Product Change Notification

Date Issued :	November 21, 2024	PCN Number :	516232
Reason for Change :	Retraction		
Description of Change :	This notification is to advise you of a modification to a previously issued PCN. Please refer to the information below for details regarding the amendment		
Assessment of Change :	Dimension analysis		
Planned Implementation Date :	December 31, 2024		
Customer Sample Availability Date:	December 20, 2024		
Last date to request Samples by Customer :	November 30, 2024		
Please note if Samples are not requested as per Customer Samples Request date, it may take additional 4-6 weeks to arrange Samples.			
Traceability Code Markings / Date :	No special marking on the product or packaging

Date Issued :	August 18, 2023	PCN Number :	514062
Reason for Change :	Change to Product		
Description of Change :	Molex is introducing a slight geometry change (relief slot) to the MX150 product family to eliminate the need for moisture conditioning of the connector housing prior to the finished goods assembly process.		
Reason for Short Notice :	Special Request		
Assessment of Change :	Dimensional analysis		
Planned Implementation Date :	April 04, 2024		
Sample Availab

Change Overview

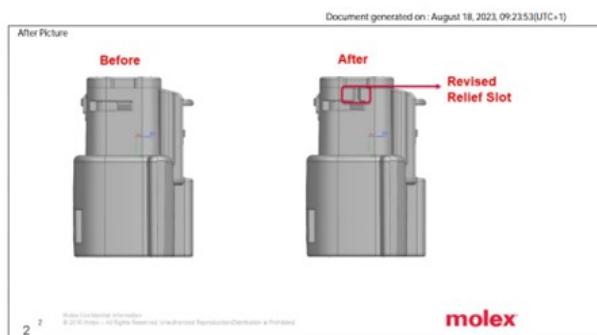
- Molex is introducing a slight geometry change (relief slot) to the MX150 product family to eliminate the need for moisture conditioning of the connector housing prior to the finished goods assembly process. Refer to existing and revised housing geometry shown.

- The existing connector housing design requires moisture conditioning to avoid damage during the assembly process. The revised design is a permanent change that eliminates the potential damage and the need for moisture conditioning.

- There is no impact to part fit or function. There is a visual difference between the existing and revised connector housing where plastic has been removed for the relief slot.

- This PCN is a full retraction for the previous PCN 514062.
- Molex has identified and is exploring a list of countermeasures in lieu of the proposed design change to prevent damage to the connector during the assembly process.
 - For this reason Molex are retracting the PCN and will re-initiate them should there be a need in the future.
 - Customers will continue to receive parts with the existing design level.
- Product Impact
 - No impact to part fit, form or function. No change in finished goods part numbers.
- Part Number Impact
 - Full retraction, please refer to previous PN list
- No Qualification reports, PPAP, or samples will be available for this change due to the full retraction.
